**ADDENDUM NO. 3 TO PROJECT NO. 43188**

**CONSTRUCTION WORK  
WATERPROOF GRAND STAIRCASE BETWEEN CEC AND PLAZA  
EMPIRE STATE PLAZA  
ALBANY, NY**

April 1, 2014

**E10** EXPANSION JOINT @ C.E.C TERRACE  
 SCALE: 3" = 1'-0"

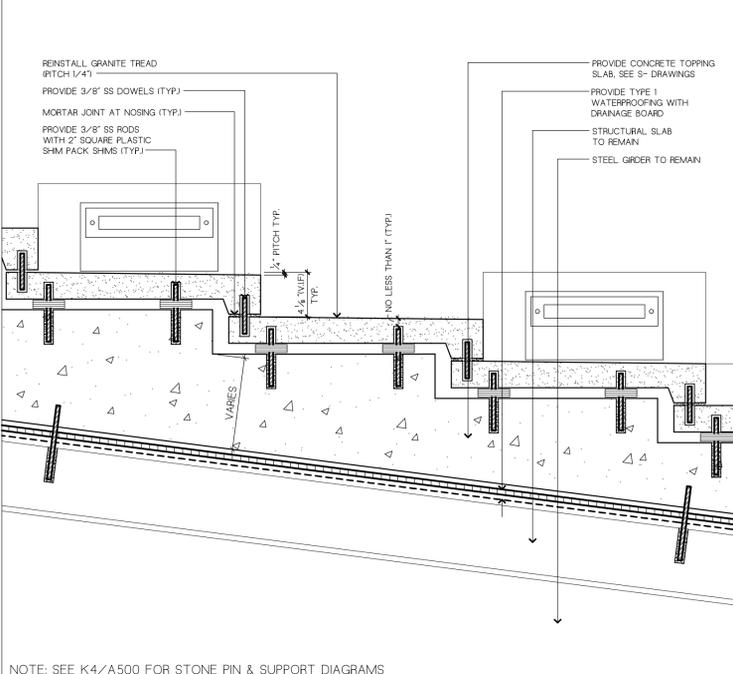
5. Drawing No. A500, STAIR INSTALLATION DETAILS:
  - a. Detail E10/A500: Change the Note, "Low Density Styrofoam" to read "Non-Compressible Rigid Insulation."

**K10** TRENCH DRAIN INSTALLATION @ PLAZA DETAIL  
 SCALE: 3" = 1'-0"

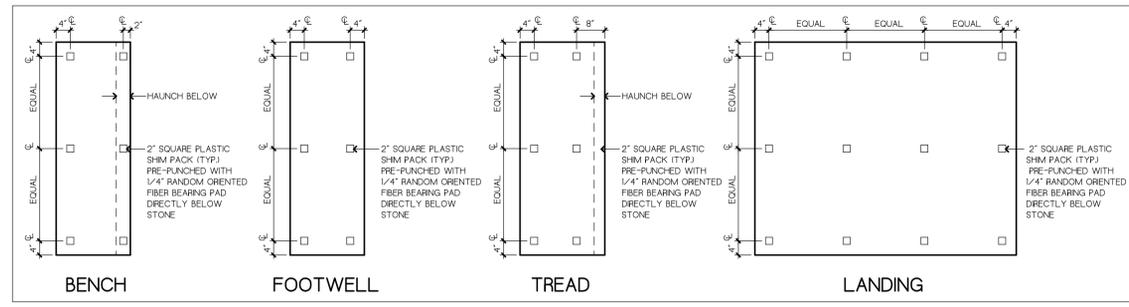
- b. Detail K10/A500: Change the Note, "Provide Layered Rigid Insulation" to read "Provide Layered Non-Compressible Rigid Insulation."
6. Drawing No. A501, STAIR INSTALLATION DETAILS:

**CONCRETE TOPPING SLAB PLAN – THIRD FLIGHT**

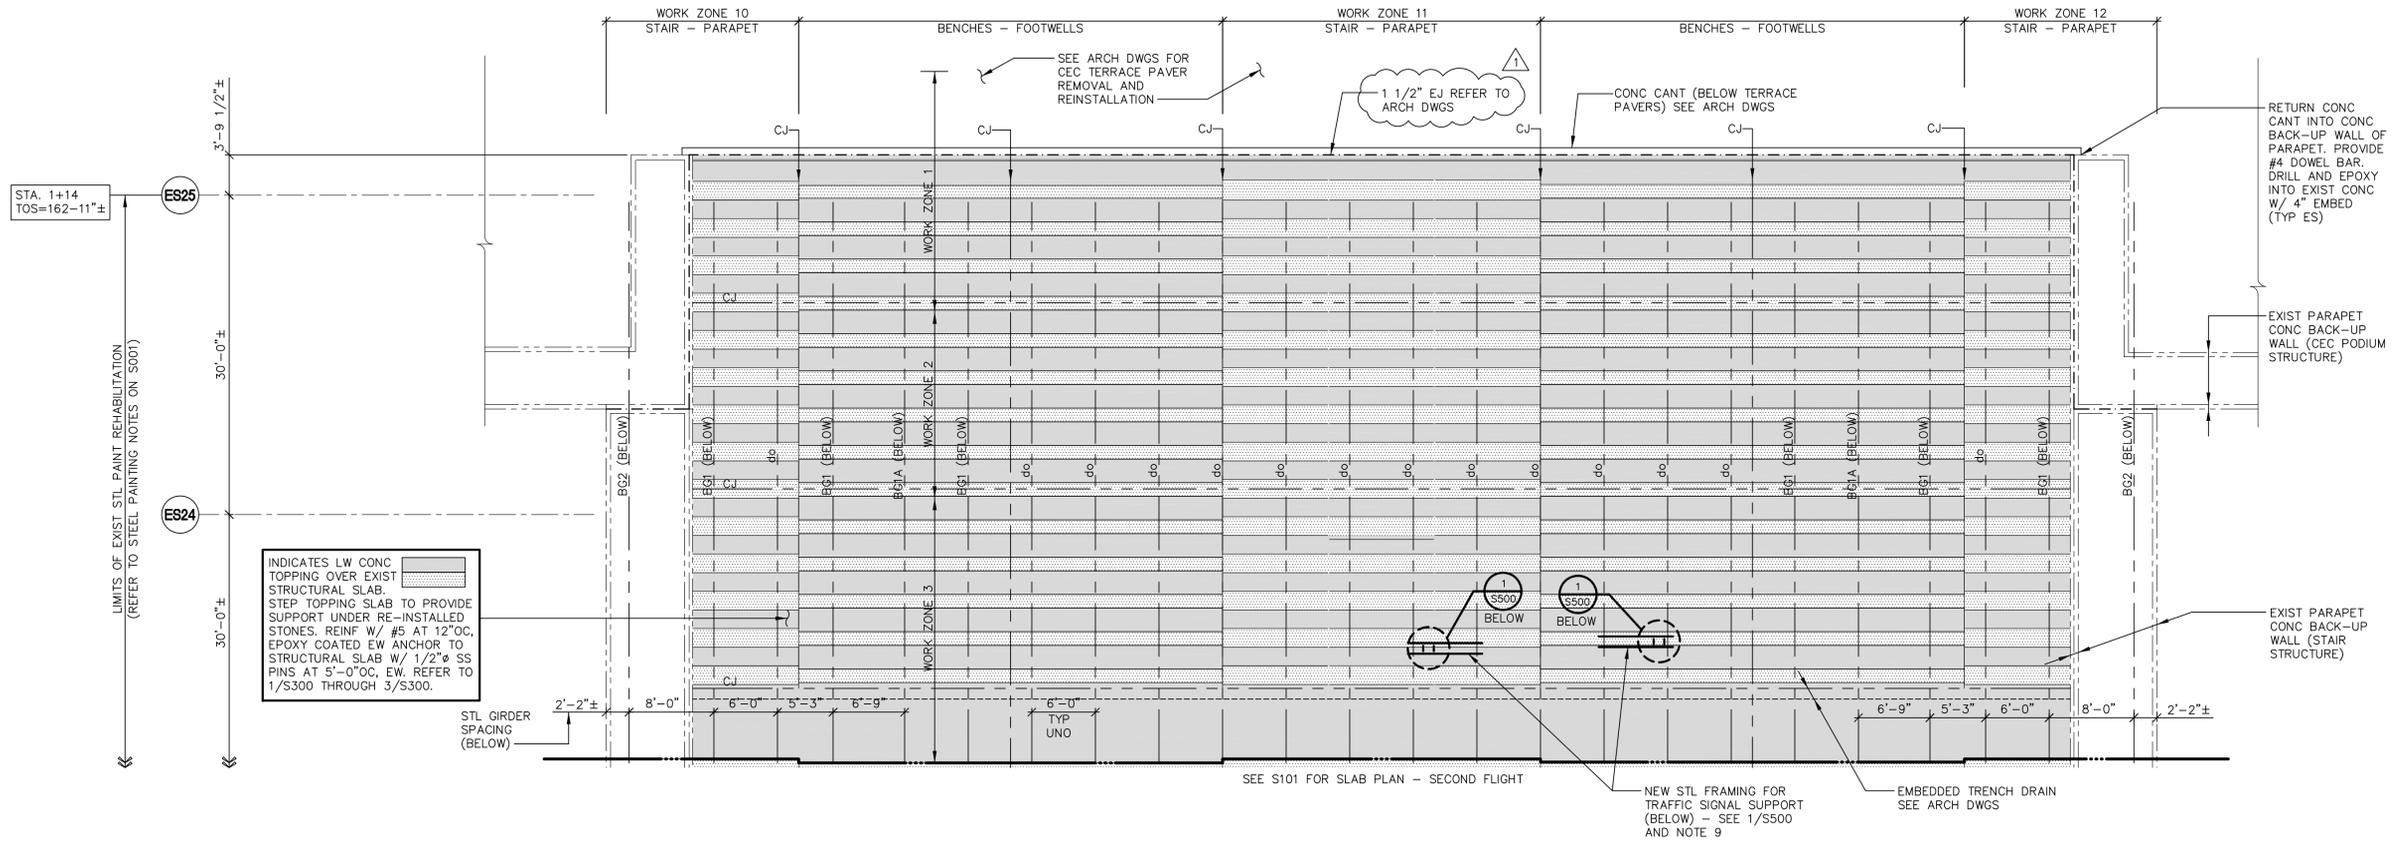
6. CJ – Indicates construction or contraction joint. Approximate locations of joints are shown. Coordinate locations with work zone limits."
9. Drawing Nos. S100, S101, and S102: Add the following to the end of Plan Note 3 "Assume 400 linear feet of structural slab crack repair total of all flights".

**CONCRETE TOPPING SLAB PLAN – FIRST FLIGHT**

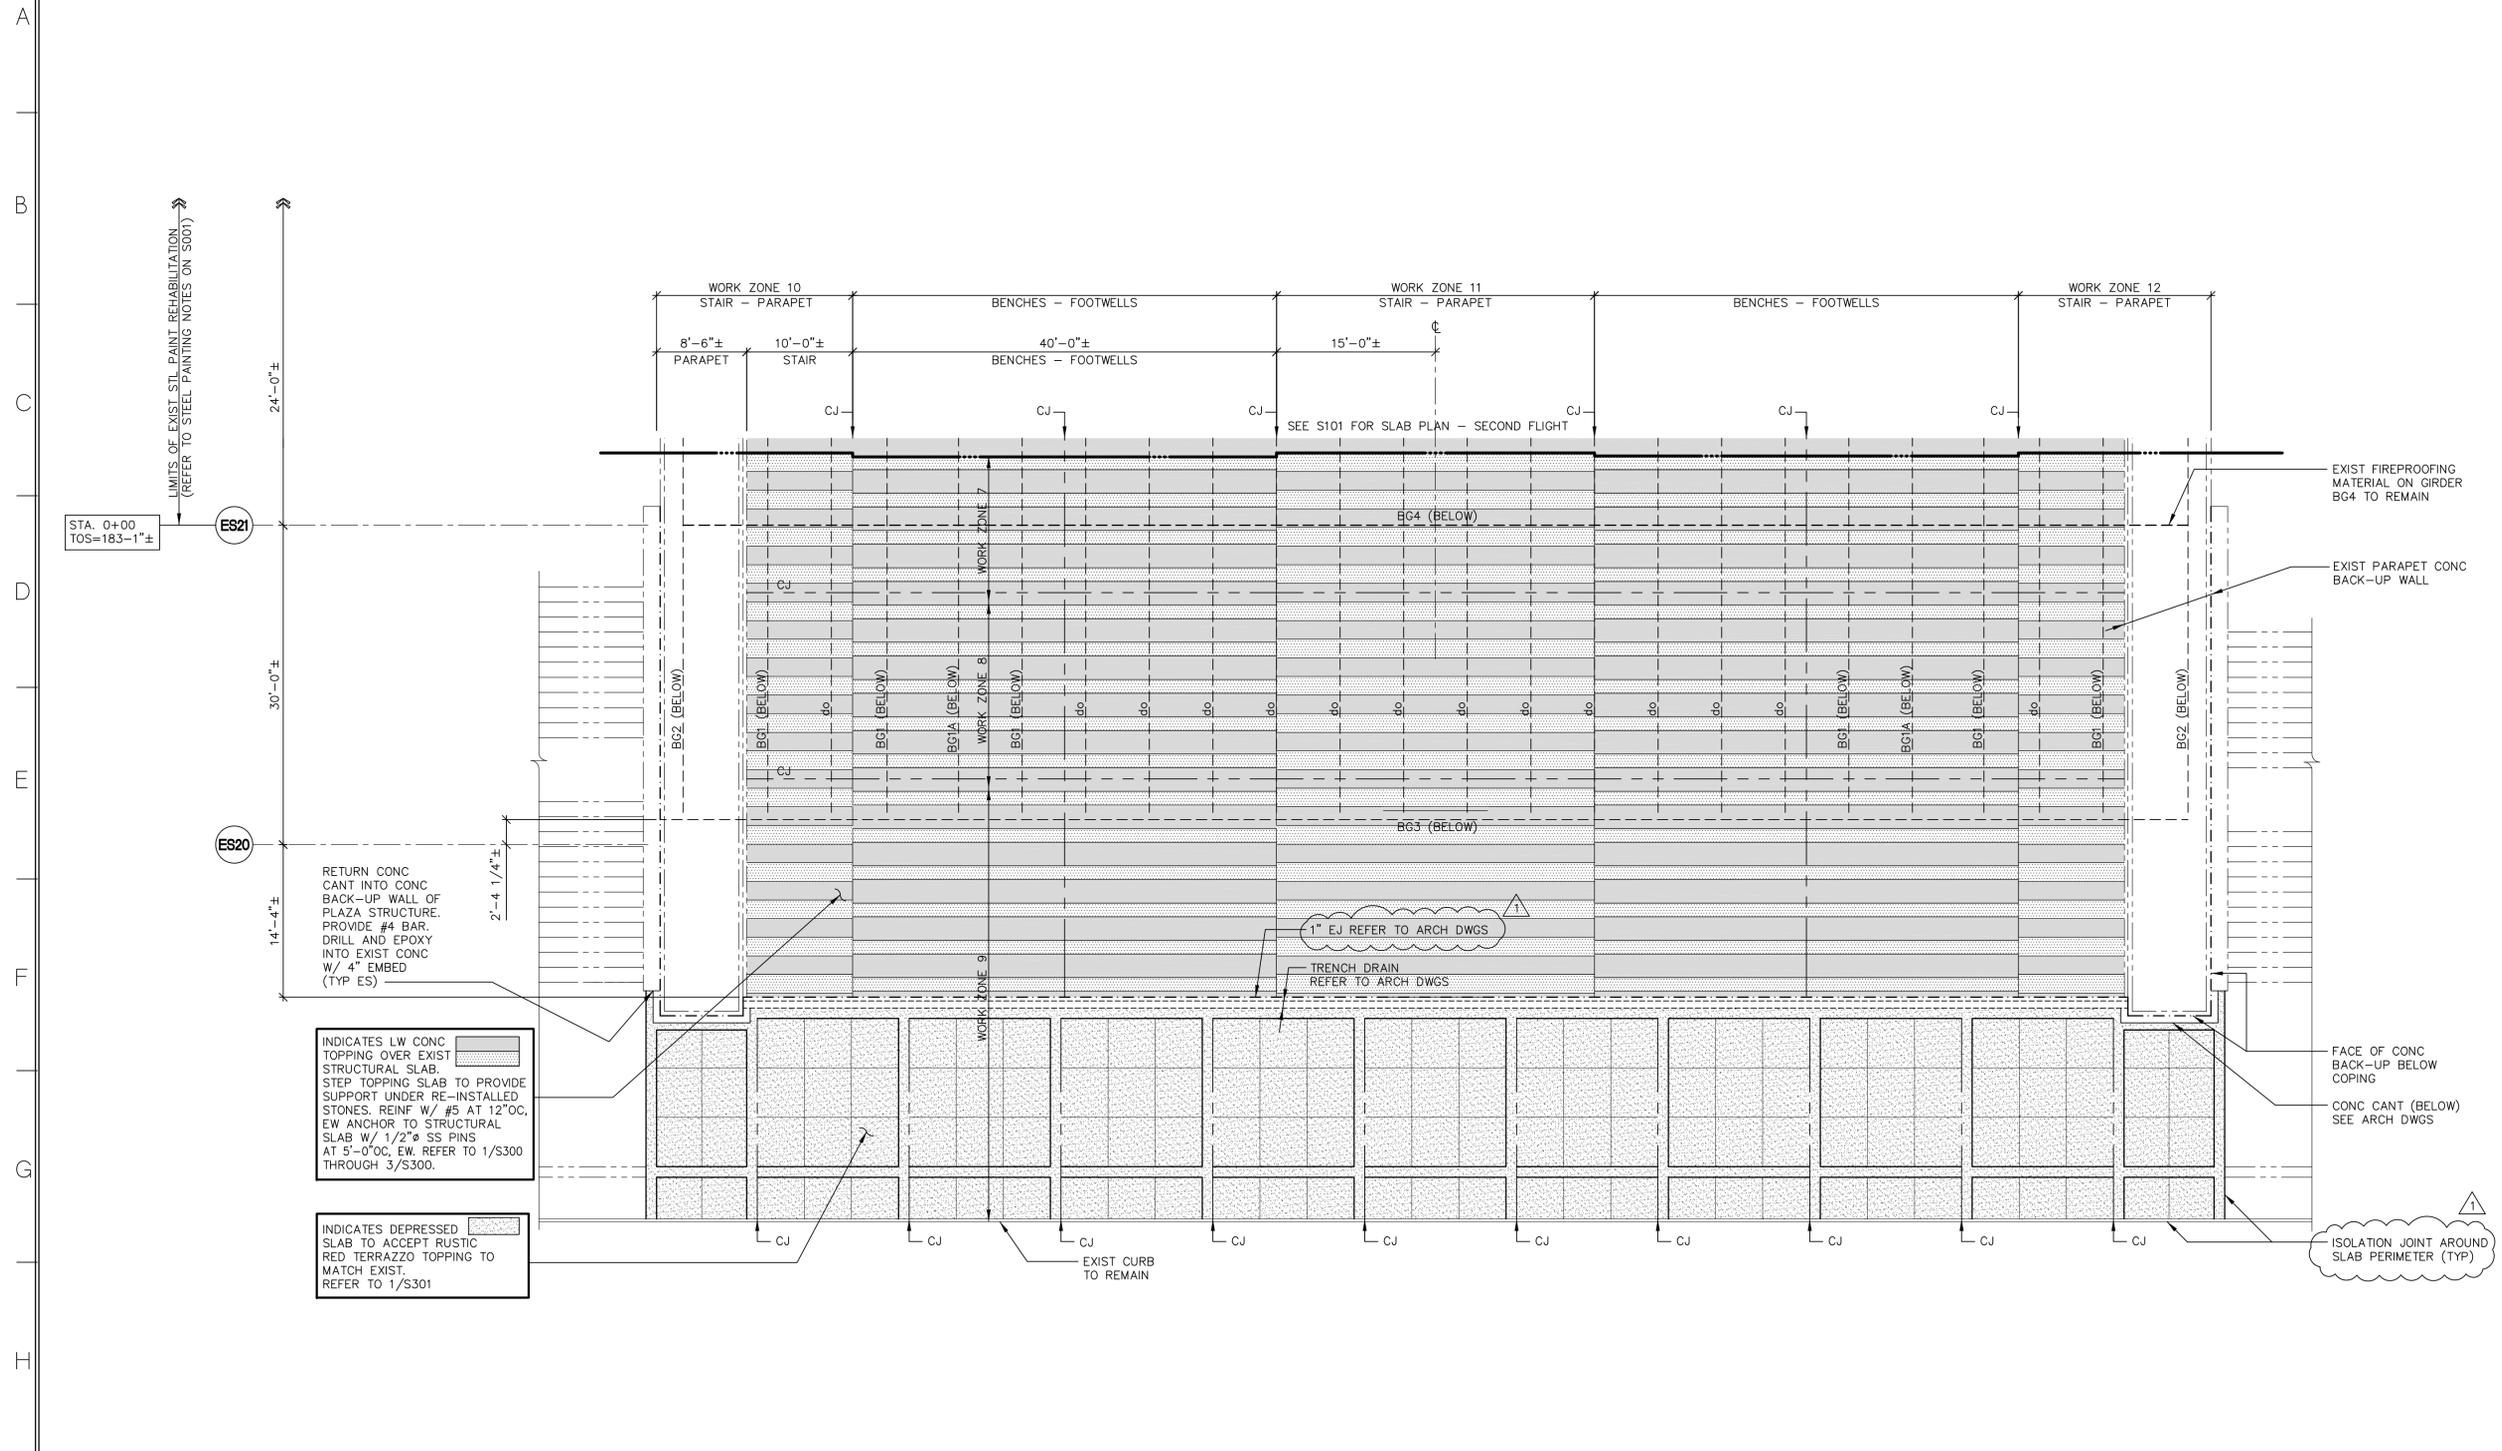
- Wind Loads: 37.6 ± psf uniform area load.
    - Seismic Loads: 0.932 x component weight".
8. Drawing No. S101, PLAN NOTES, Note 6: Delete this Note in its entirety, and replace with the following:
